## STAFF REPORT

## HISTORIC DOWNTOWN ADVISORY COMMISSION

**1. CERTIFICATE OF APPROPRIATENESS**

Applicant: 3 Pillar Homes  
 Location: 67 Grace Dr S  
 Zoning: DB – Downtown Business District  
 Request: Review and approval of a proposed single-family residence.

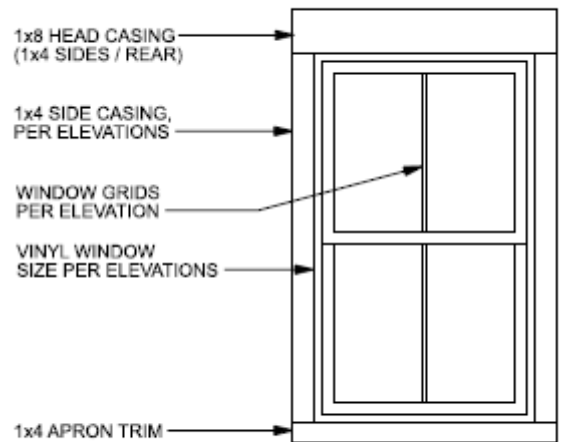
- Proposed Roofing: Tamko Heritage Shingles in rustic black.
- Staff Comments: The proposed roofing meets the guidelines.

ENLARGED WINDOW ELEVATION

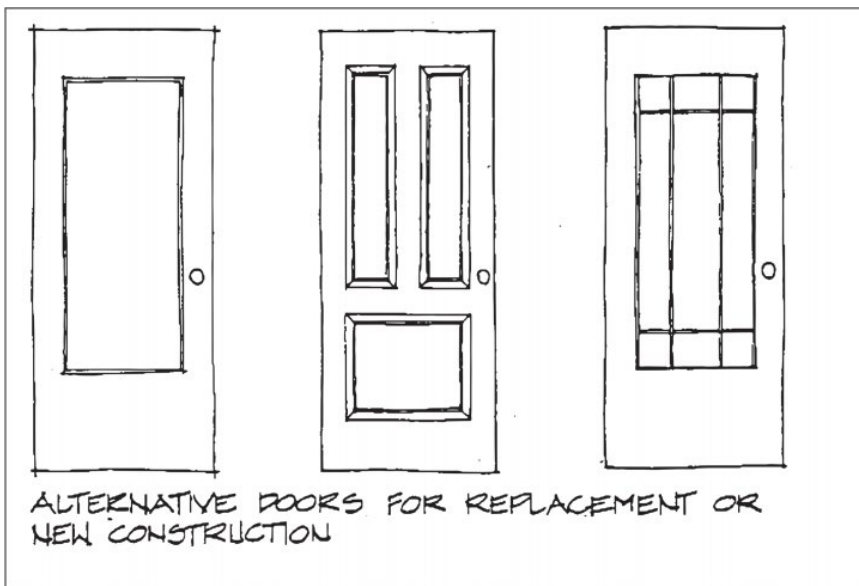
- Windows (PAG, pg. 47)
  - “There are three basic types of windows which are historically correct within the Historic District, double-hung, ‘ribbon’ and fixed sash. The most common type of window in the City is double-hung, straight-topped, and has tall, thin proportions. These windows range from two to three times as tall as they are wide. Two-over-two or one-over-one pane divisions are typical.”
  - “New construction within the Historic District should use window types and proportions characteristic of Powell. Double-hung windows in tall, thin proportions are appropriate in almost all types of Powell buildings.”
    - Proposed Windows: See drawing set and window elevation provided.
    - Staff Comments: The applicant has updated the windows to meet the architectural guidelines.

- Proposed Doors: See drawing set, and note that exterior door trim is similar to the window elevation provided above.
- Staff Comments: The front door has been updated to match the alternative doors for new construction as outlined in the PAG. Although a double-door is proposed rather than a single-door, the style meets the guidelines.

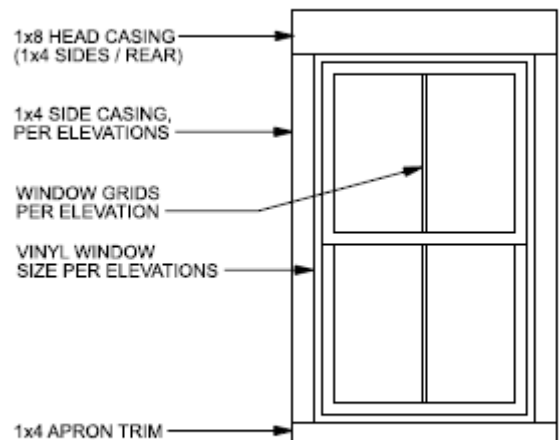
- Proposed Roofing: Tamko Heritage Shingles in rustic black.
    - Staff Comments: The proposed roofing meets the guidelines.

**ENLARGED WINDOW ELEVATION**

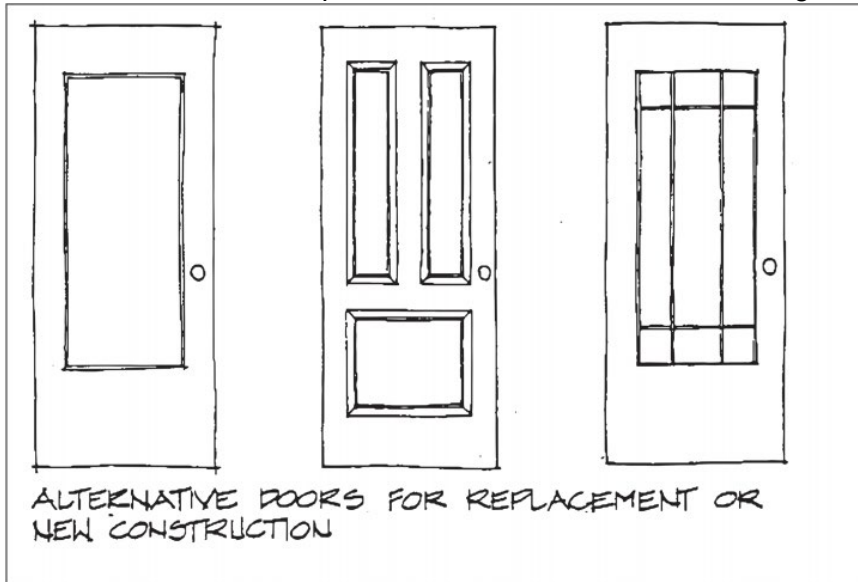
- Proposed Windows: See drawing set and window elevation provided.
    - Staff Comments: The windows on the front elevation are appropriate, with the exception of the windows above the garage, and the small window above the front doors. Several windows on the north and south elevation do not meet the proportions of the guidelines. Staff recommends the applicant work with the Architectural Advisor and Staff to rectify.

- Proposed Doors: See drawing set, and note that exterior door trim is similar to the window elevation provided above.
- Staff Comments: The front door is not consistent with the guidelines, as the proposed door is not a single front door, but a double, and the design contains two wood panels with glazing above, rather than the typical four wood panel design or single glazed panels above a wood one.
